## SPECIAL CONDITIONS OF PLANNING BOARD APPROVAL

DATED JANUARY 12, 2016

C-3.0

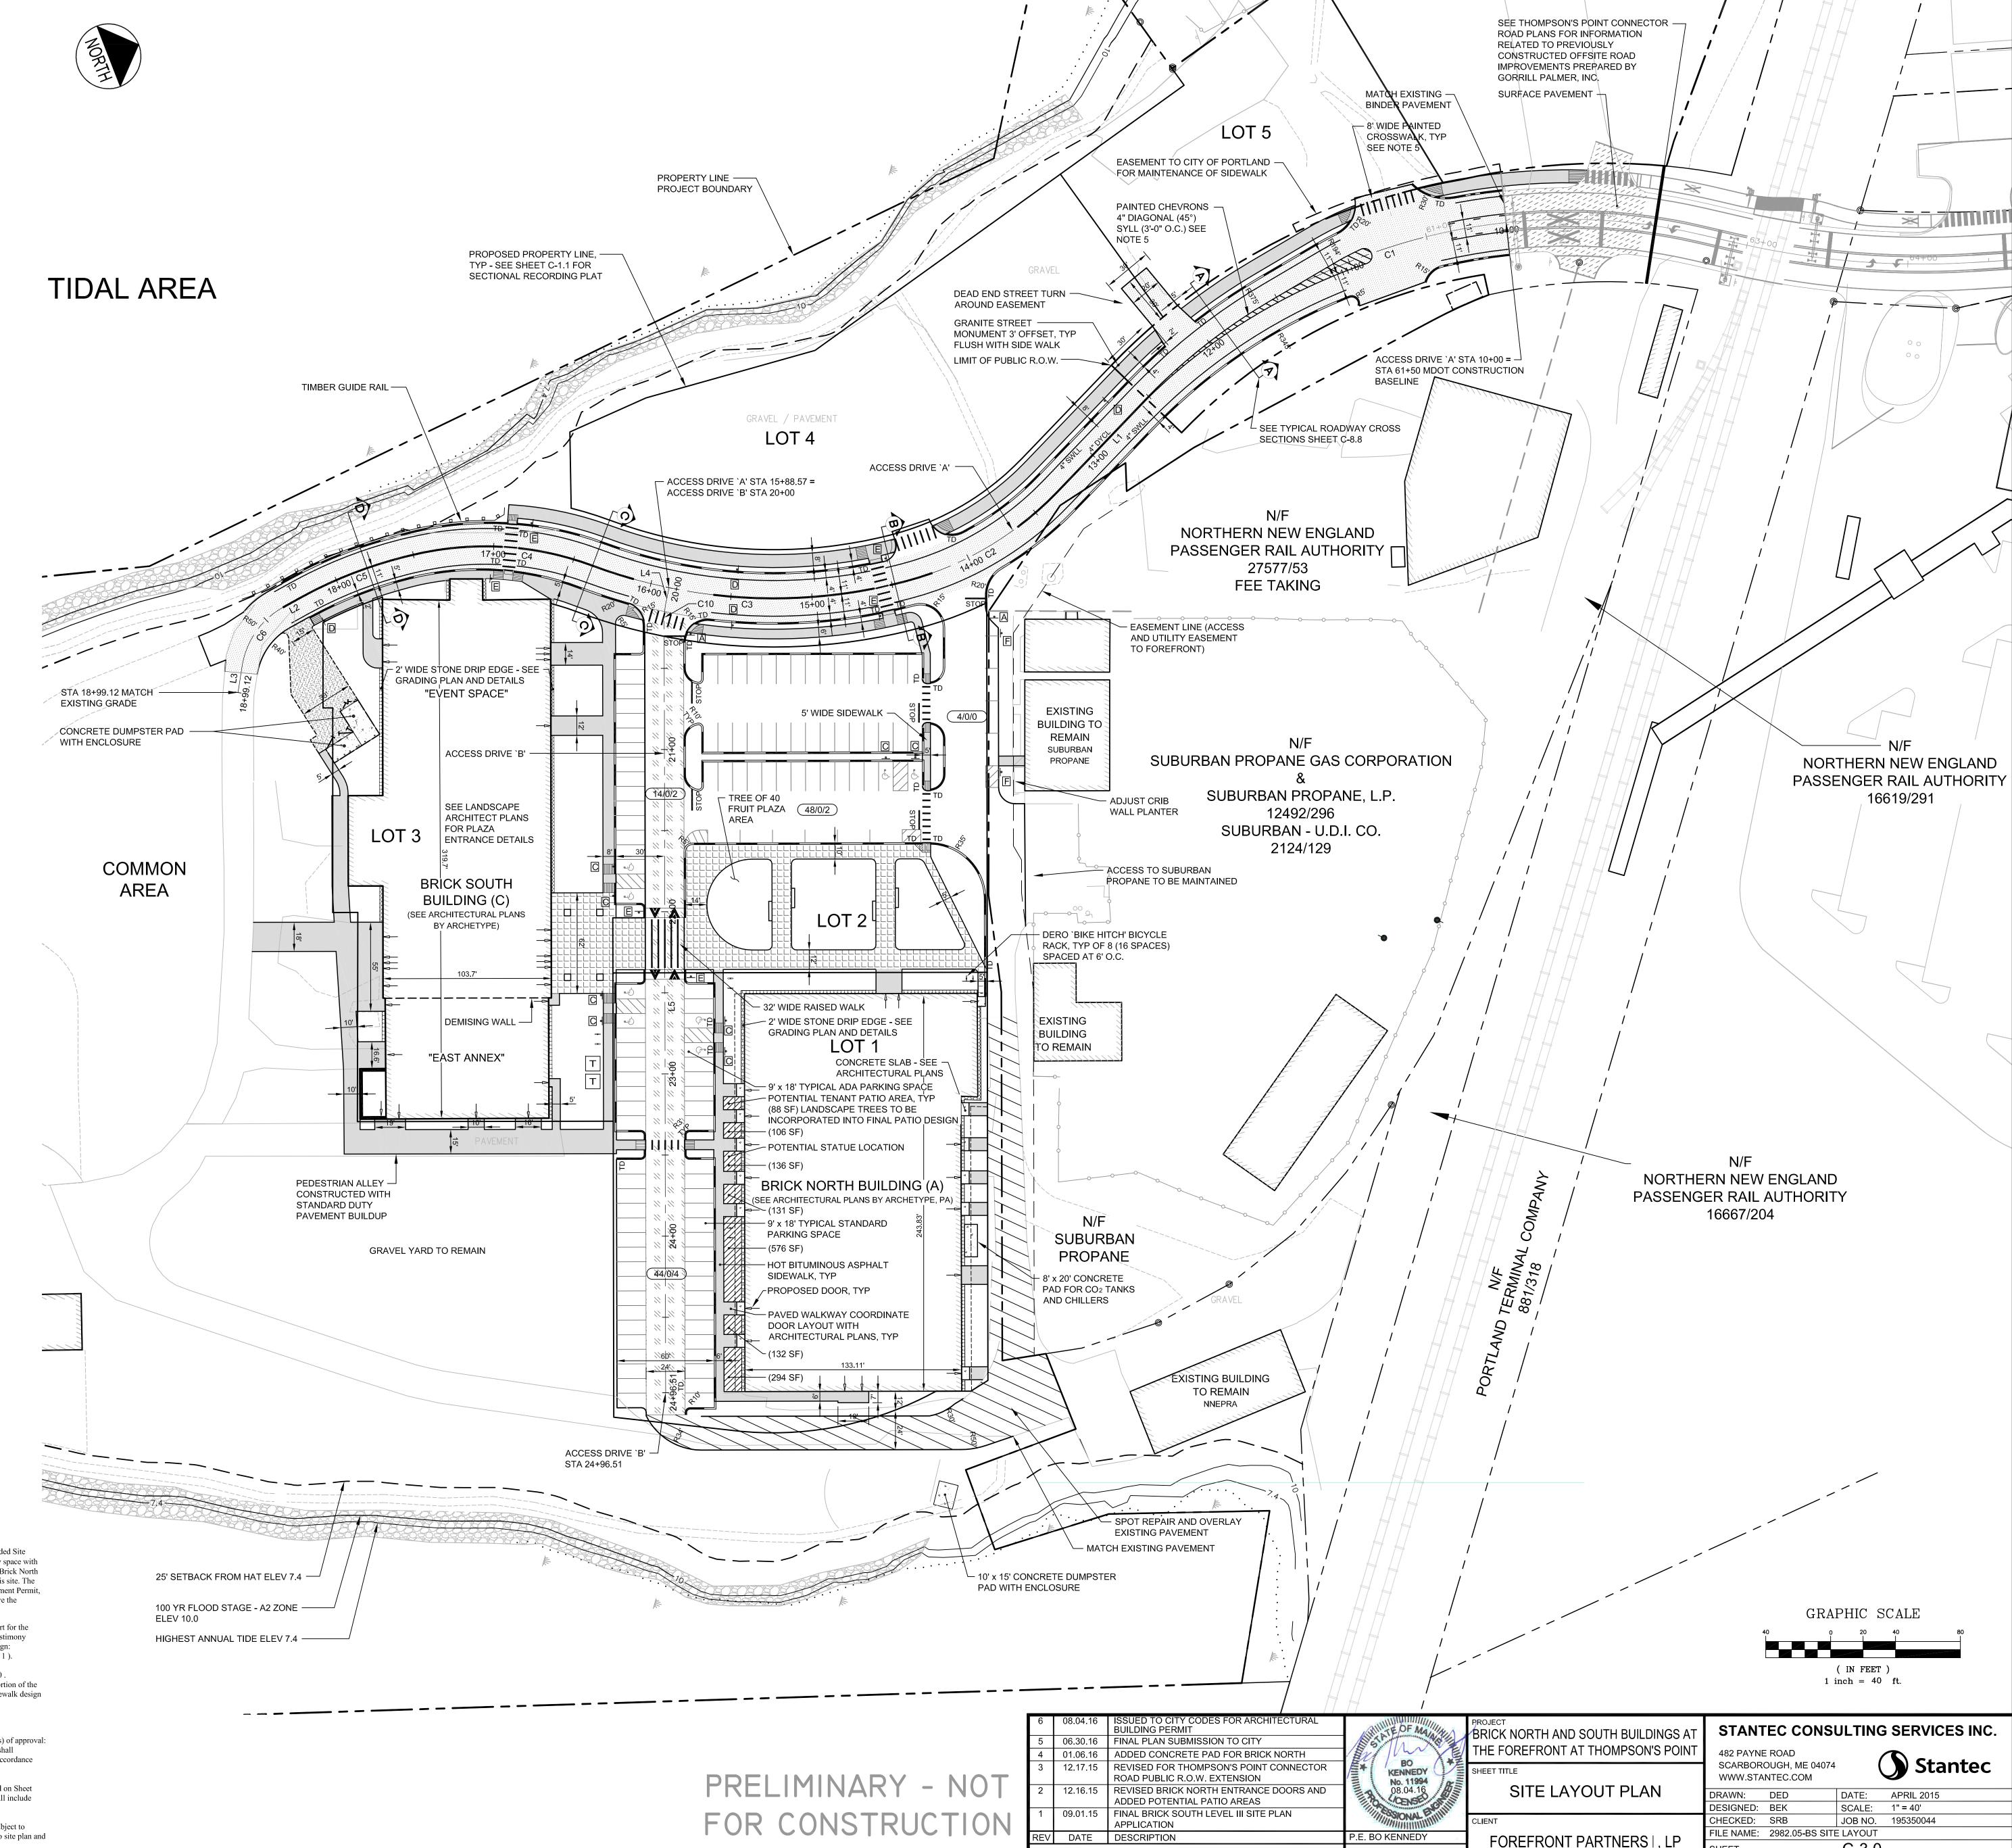
as shown on Sheet C-3.0, Overall Site Plan is (2015-133) at a future phase. 5. Figure I-2 (Collector Street Cross-Section), requiring a minimum roadway width of 40 feet for collector roads, to allow for a variable width of 30-39 feet. 6. Figure 1-2 (Collector Street Cross-Section), requiring a minimum esplanade width of 5 feet for collector roads, to allow for a 4ft wide esplanade.

2. The applicant shall provide a full construction management plan for review and approval by the Public Works Department. 3. Sidewalks and Road Improvements: At the time a Site Plan application is submitted for Buildings Fl/H (or alternate Level III proposal for Lots 14 & 15 as depicted on Sheet C-2.0, Subdivision Plan), the portion of roadway included in Sheet C-3.0, Site Layout Plan, including the easterly sidewalk and all remaining road improvements, shall include provisions for conformity with the road design depicted on Sheet C-3.0, Overall Site Plan. 4. Final landscape plan shall incorporate 2" caliper trees in 4 foot-wide esplanade.

5. The 8'x20' Concrete Pad for the storage of C02 tanks and chiller equipment on the North Side of Brick North, as shown on Sheet C-3.0, Site Layout Plan, will be subject to review by the Inspections Division, and any associated life safety reviews, before construction. The approval is based on the submitted plans and the findings related to site plan and
